PoE Plus IEEE 802.3at Classification Ad Hoc

Resolving Draft 1.0 Comments in L1 Bucket

Clay Stanford
Linear Technology
December 5 and 12, 2007
Teleconference

Table 33-11a-2-Event Physical Layer classification electrical requirements

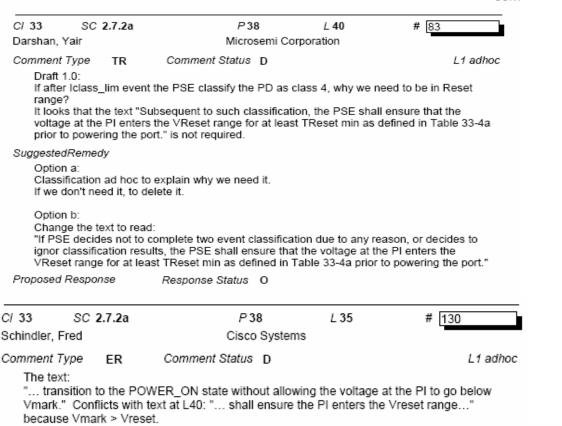
Define Mark Event Voltage range. It will make text more clear.

Define Reset Voltage range. It will make text more clear.

Label Reset Threshold Vreset_th to be more consistant.

Vreset th

___ 10V

Table 33-11a

Item 2: Add "10" to max column.

Item 5: Change Symbol from Vreset to Vreset_th

Add new item 6, Classification Reset Voltage Vreset V 0(V) 2.8(V) See 33.3.4.2.1

6 | Classification Reset Voltage | Vreset | V | 0 | 2.8 | See 33.3.4.2.1

Add this new entry

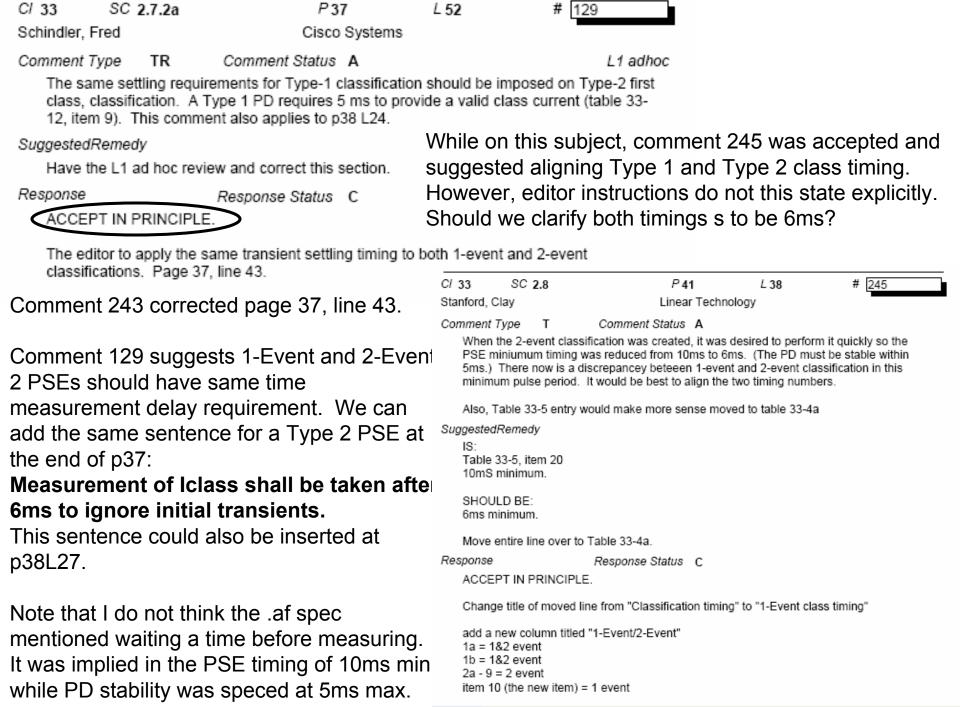
lclass is greater than Iclass_lim, the assigned class is Class4. There is no he voltage at the PI in this case. Whithout this sentence, if the 2-event classification succeeded, the PD will work correctly as class 4.

With a reset instead, the PD will work as a Type1 PD, wasting a lot of the allocated by the PSE.

Remove the sentence:

Subsequent to such classification, the PSE shall ensure that

the voltage at the PI enters the VReset range for at least TReset min as definied in Table 33–4a prior to powering the port.

ACCEPT.
